MEMORANDUM

REVIEW TYPE: Preliminary Plan of Subdivision

PROJECT NAME: Sandy Spring, Parcel B

CASE #: 120090230

PRELIMINARY PLAN

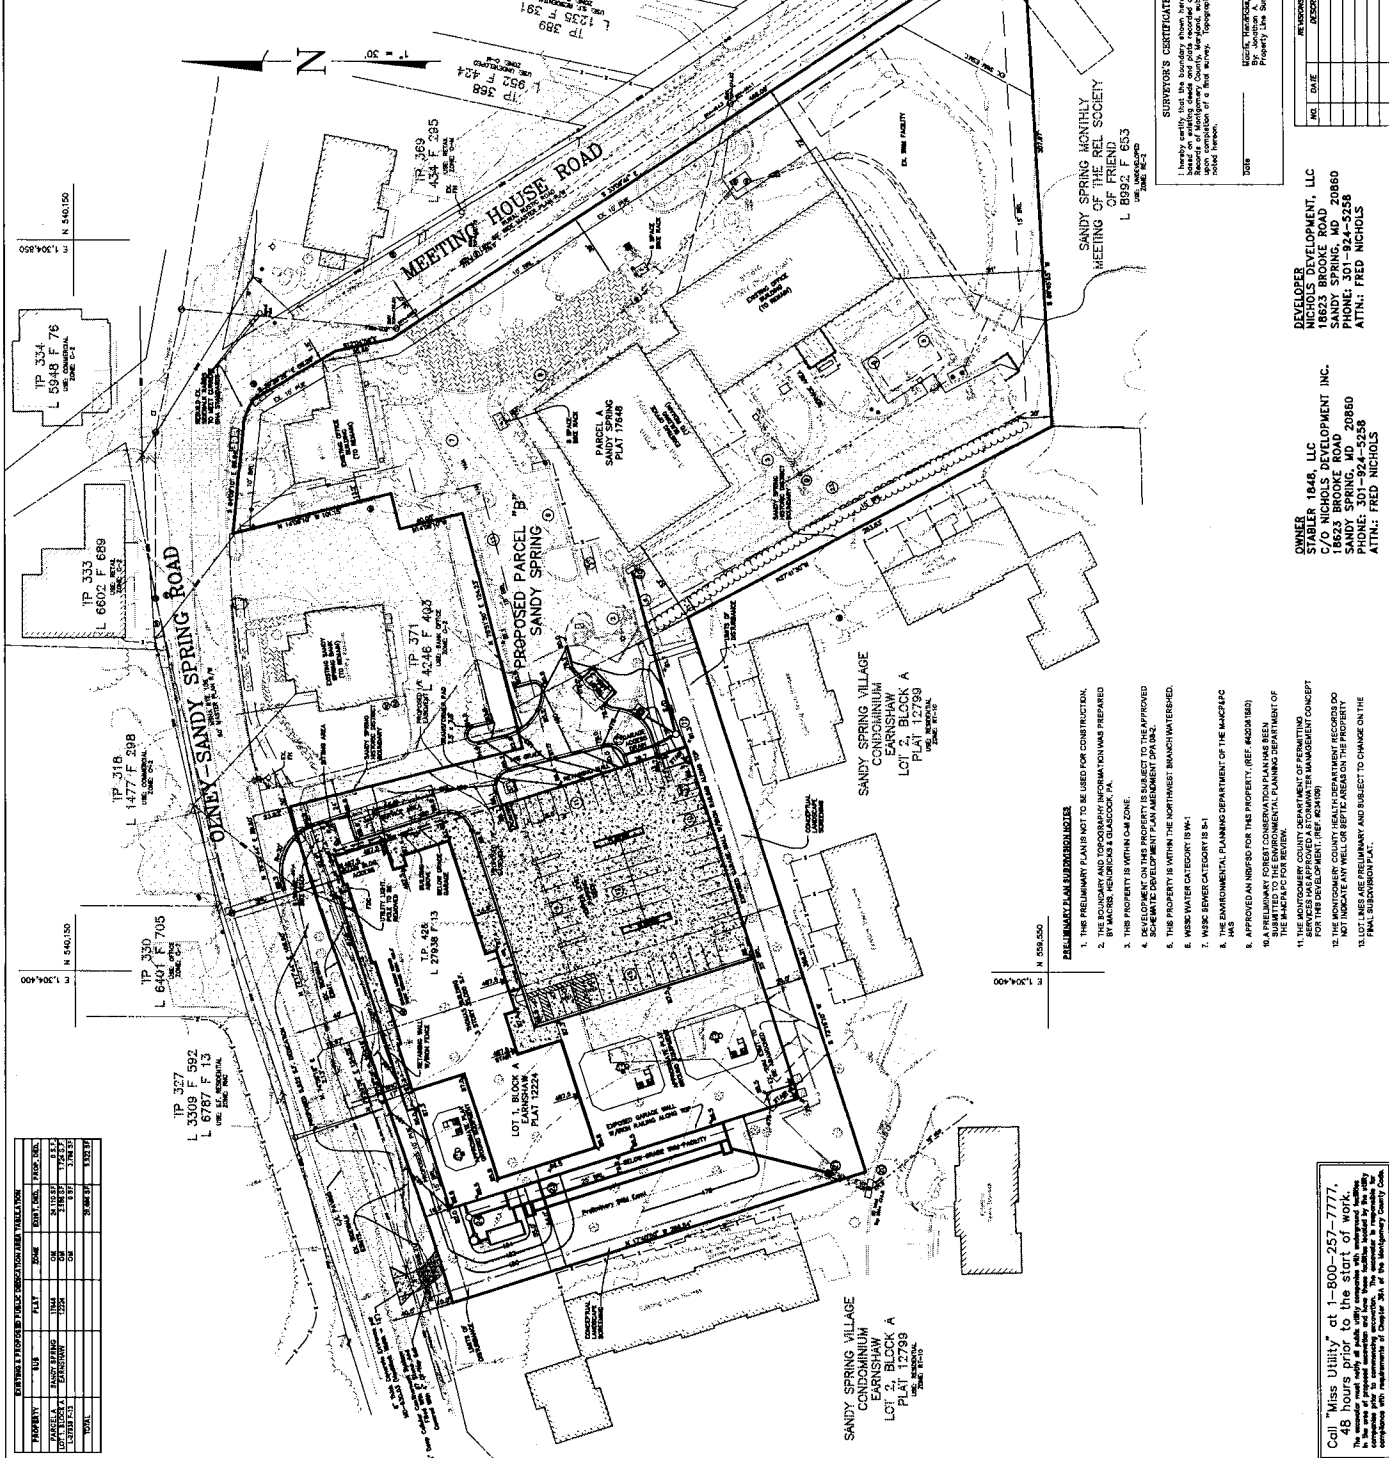
- 1) Approval under this preliminary plan is limited to one lot for 72,121 square feet of office use, 12,238 square feet of child day care use for a maximum of 196 children, and 1,718 square feet of retail use.

- 4) The Applicant must dedicate and the record plat must show dedication of 5,522 square feet of land for right-of-way for Olney-Sandy Spring Road (MD 108), for a width of 40 feet from the centerline, as shown on the preliminary plan.

- 5) The Record plat must show an easement for future dedication of 30 feet of right-of-way, as measured from the centerline, along the property frontage for Meeting House Road. The terms of this easement must be recorded by the applicant in a separate document, and the liber and folio of the document must be referenced on the plat. The terms must be submitted to MNCPPC staff for review and approval prior to recordation of the plat. The terms will specify requirements for right-of-way dedication in the event that the historic structure located in the southwest quadrant of the intersection of Olney-Sandy Spring Road (MD 108) and Meeting House Road is removed from the property.

- 7) At the time of filing of site plan, the Applicant must submit for staff review:
 - a. An access management plan/stripping plan and a sidewalk detail plan for MD 108 (between Meeting House Road and Norwood Road) and for Meeting House Road (between site driveway and MD 108)

- b. An on-site vehicle/pedestrian circulation plan considering existing and proposed uses on the property and the adjacent townhouse community.
 - 8) Prior to recordation of the plat, the existing Adequate Public Facilities (APF) agreement for the property, dated January 12, 1990, must be terminated and all parties released from their rights and obligations thereunder.
